City of Surrey PLANNING & DEVELOPMENT REPORT Application No.: 7921-0082-00

Planning Report Date: April 17, 2023

to permit the development of a 10,230 square metre business park building.

LOCATION: 15513 – 28 Avenue

SITE SECTION DETAIL 1

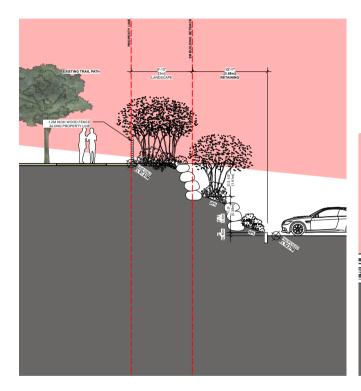
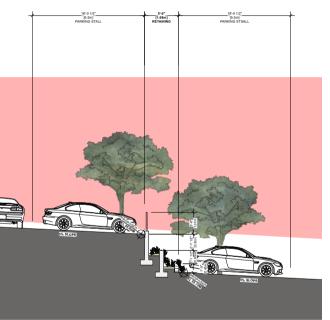
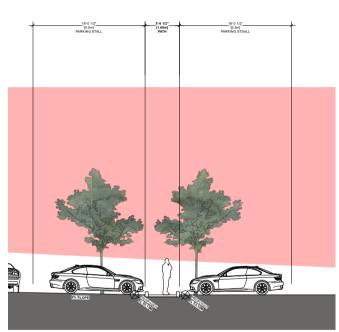
3. The sloping site and the nature of the 'sunken' parking lot create a need for significant retaining walls that will be visually very prominent with little available topsoil to support plants for screening. Design development is recommended with the project engineer to confirm design and materiality and coordination with the architect and landscape architect to adjust the parking as required to ensure there is adequate width of topsoil to support plants that can screen or buffer views of the retaining wall.

The parking lot site grading has been adjusted in order to provide the highest elevations wherever possible. Please note the site is restricted by BC Hydro cable line setbacks. Furthermore, the project aims to provide less than 5% slope wherever suitable to create the most comfortable walking experience for its end users.

PLAZA ENLARGED PLAN

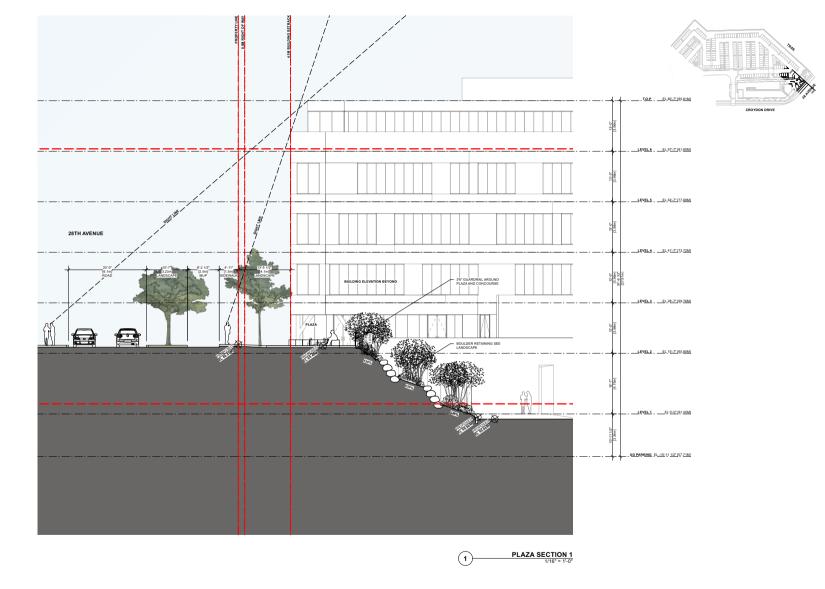
2. The plaza appears to be more of a circulation space with the north edge of the plaza pushed up against the retaining walls and presumably a guard rail. Consider design development to create some planted separation between the parking lot, provide a more direct connection to commercial space, and provide a plaza that is more focused on areas for social interaction.

Please see response above.
